Revision 02: Width of top section of timber frame to sides of rooflight reduced from 72mm to 65mm. 3mm aluminium packing strips shown below
Rafterline sections. Top flashing/ back gutter detail divided into two sections to allow flashing to be installed before rafterline sections and glazing are fitted.
Notes shown in blue text to highlight revisions

PROJECT STATUS	RIBA Stage 5
CLIENT	Manchester City Council
PROJECT	Our Town Hall
DRAWING TITLE	Rooflight details for existing openings in roof slope NR02
SIZE & SCALE	A1: 1 : 5
DRAWING STATUS	S4 - Construction

DRAWING NO. OTH-PUR-TH-RF-DWG-A-7099 02

Section A-A detail at mid point of back gutter

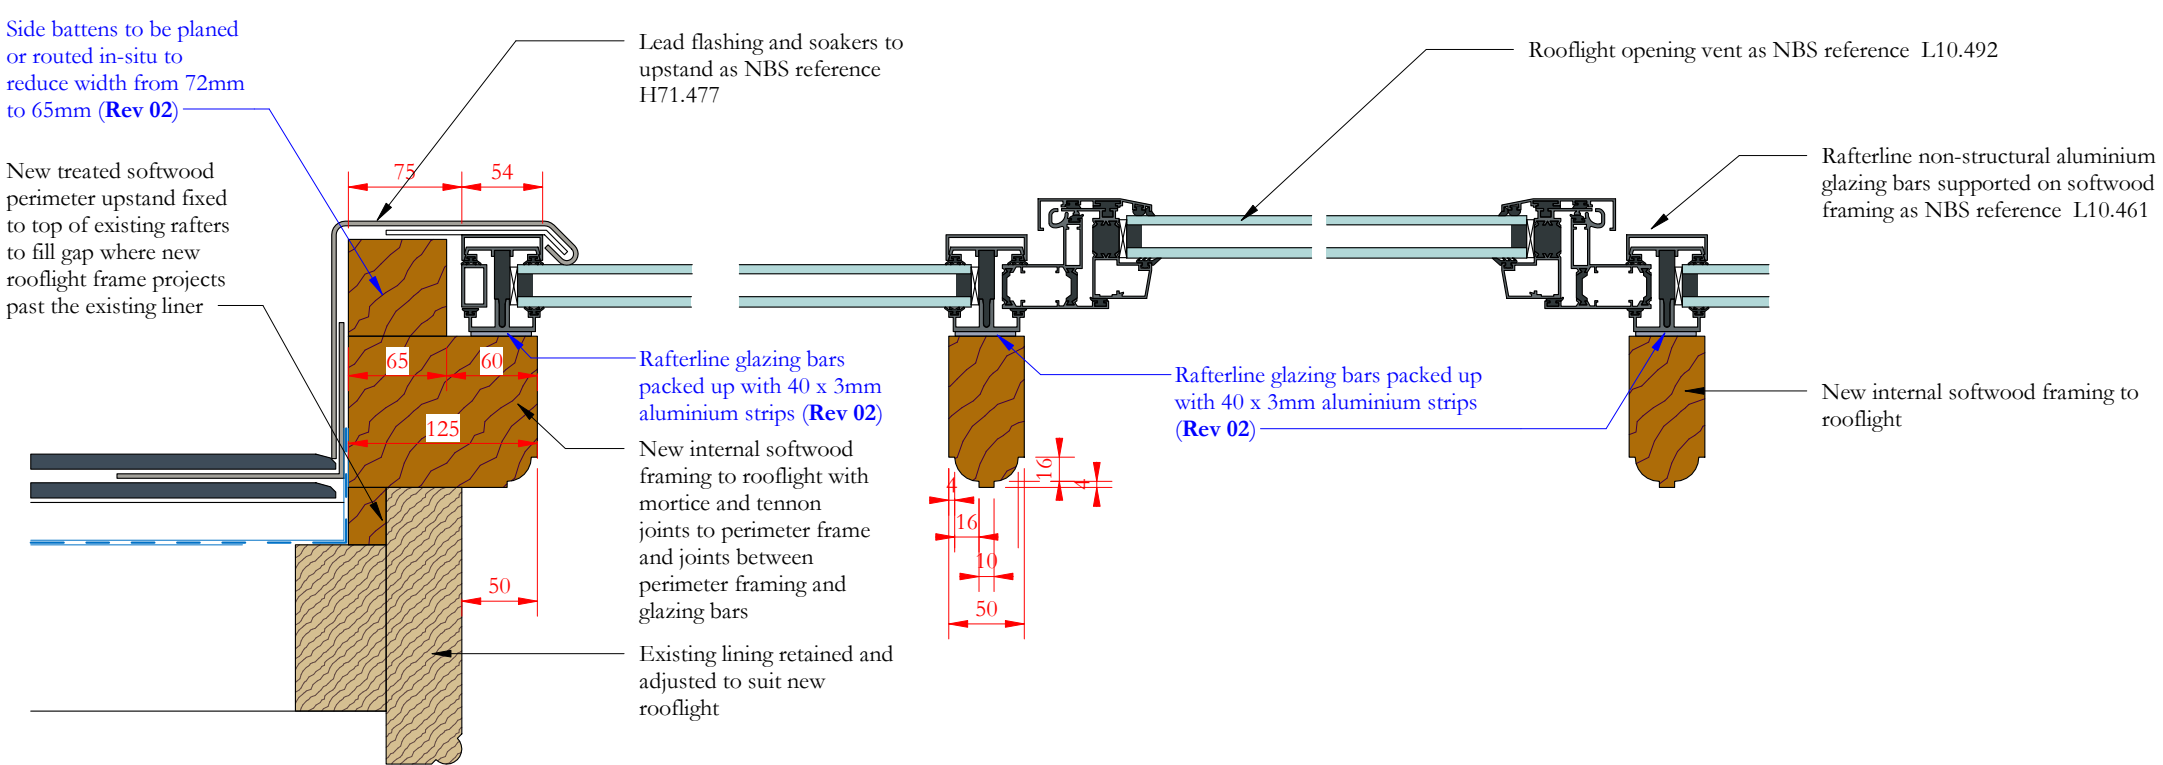
Revision 01: Back gutter detail added for rooflights exceeding 2250mm in width

Back gutter and flashing detail for rooflights exceeding 2250mm in width
